JAFP-14-0102
August 21, 2014

Subject: Response to Request for Additional Information (RAI) Associated with Near-Term Task Force (NTTF) Recommendation 2.1, Seismic Hazard and Screening Report
James A. FitzPatrick Nuclear Power Plant
Docket No. 50-333
License No. DPR-059

RAI Responses

Attachment 1 – JAF Turbine Building Complex Structural Model Developed for Seismic Design

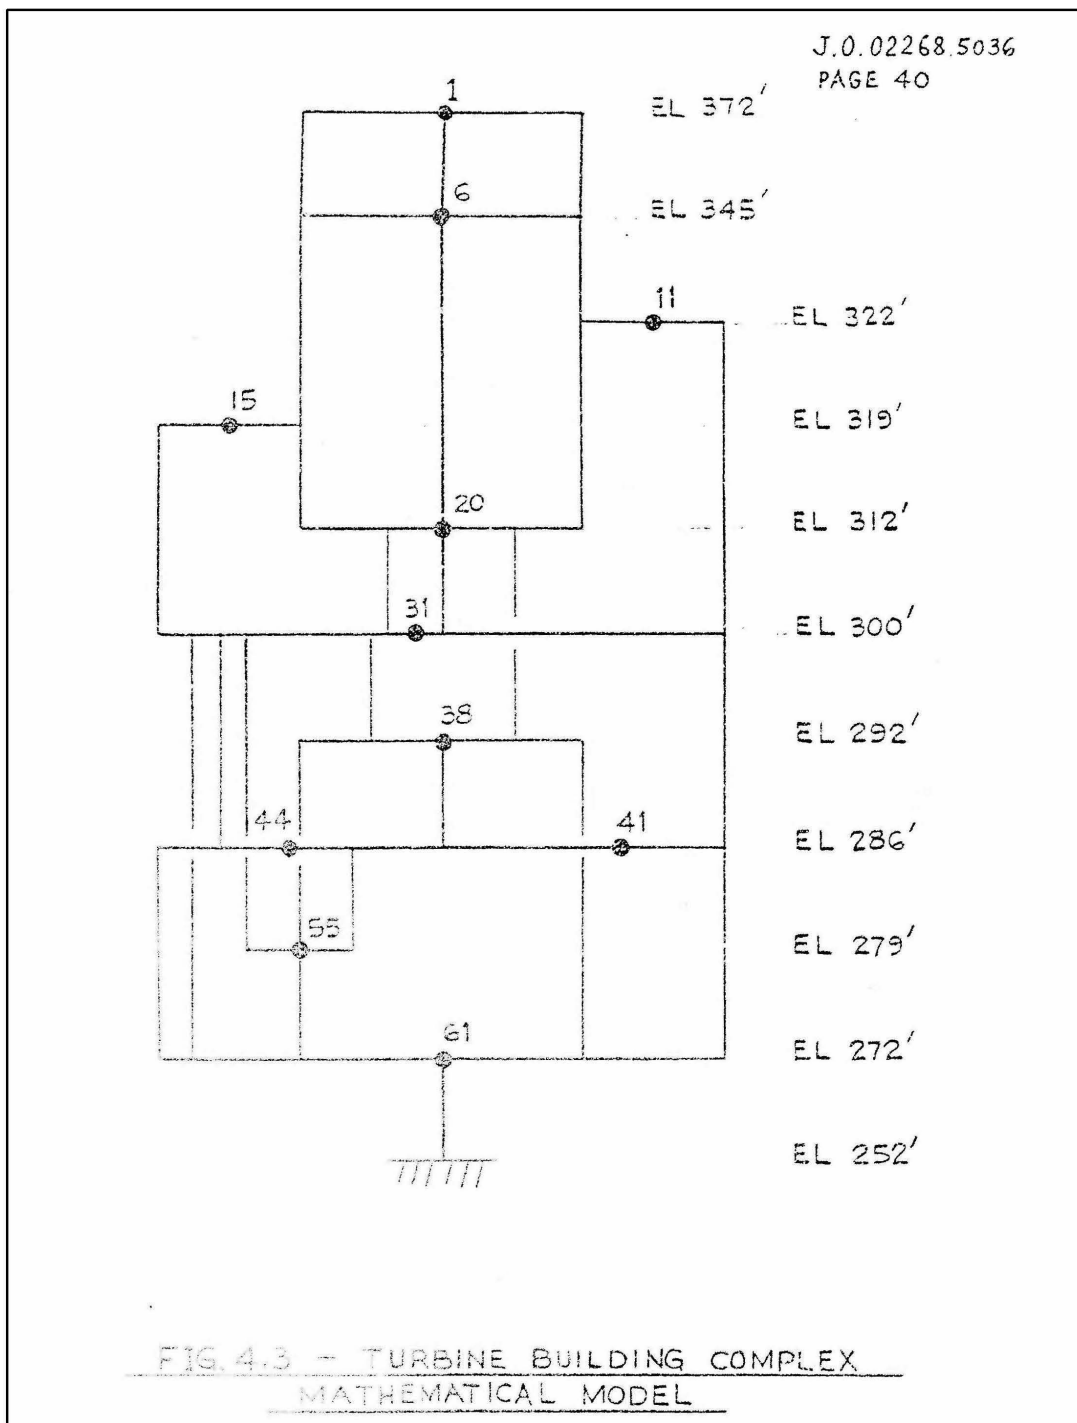
Appendix B of the seismic hazard screening report states that criteria in Table 2-3 from EPRI NP-6041 which is intended for use with structures designed as Seismic Category I structures was applied to the Seismic Category II turbine building as a basis for screening out the turbine building from the seismic margin analysis. Justifications provided for application of EPRI NP-6041 Table 2-3 in this manner include the use of lower damping values and other constraints used in the Operating Basis Earthquake (OBE) analysis of the turbine building.

- a. In the IPEEE, EPRI NP-6041 screening criteria intended for Seismic Category I structures was applied to the Seismic Category II turbine building. The turbine building, as a Seismic Category II structure, could have been designed using local building codes. The seismic performance of buildings designed using local building codes may differ significantly compared to buildings designed in accordance with NRC guidance for Seismic Category I structures. Due to these potential differences, similar design peak ground acceleration is not considered a sufficient justification for screening. Provide additional explanation to justify the application of the EPRI NP-6041 screening criteria intended for Seismic Category I structures as applied to the Seismic Category II turbine building.

- b. It is unclear in Appendix B what is meant by "constraints" used in the OBE analysis. Provide additional clarification and explanation on what is meant by constraints used in the OBE analysis and how that affects the design of the turbine building.

- c. The damping value used in the OBE analysis was not clearly indicated. Describe what was the damping value used in the OBE analysis and why is it appropriate for your site.

- a. The Turbine Building Complex at the James A Fitzpatrick Nuclear Power Plant (JAF) includes the Turbine Building, Administration Building, Radwaste Building, Screenwell-Pump House and Emergency Diesel Generator building. All of these buildings are structurally connected and, thus, a single structural model was developed as part of the seismic design basis. Parts of this complex are designated as Class I structures; the balance are Class II structures. As stated in Section 12.4.6.3 of the JAF Updated Final Safety Analysis Report (UFSAR):

"Due to the interconnection of Class I and Class II structures, namely the Control Room, Turbine Building, Emergency Generator Building, Screenwell-Pumphouse Building and the Radioactive Waste Building, the combined structures were modeled and a dynamic analysis was performed as described in Section 12.5."

State-of-the-art seismic analysis for that time frame was performed by developing a horizontal and a decoupled vertical mathematical model. The horizontal model is depicted in Attachment 1, and the lumped masses depict all of the structures comprising the turbine building complex (both Class I and Class II).

The UFSAR specifically notes that for the Class II structures within the Turbine Building Complex, both the OBE and Design Basis Earthquake (DBE) were evaluated using this combined model. However, due to more conservative characterizations of damping and allowable stresses for the OBE case, DBE level earthquake loading did not govern the design over the OBE level:
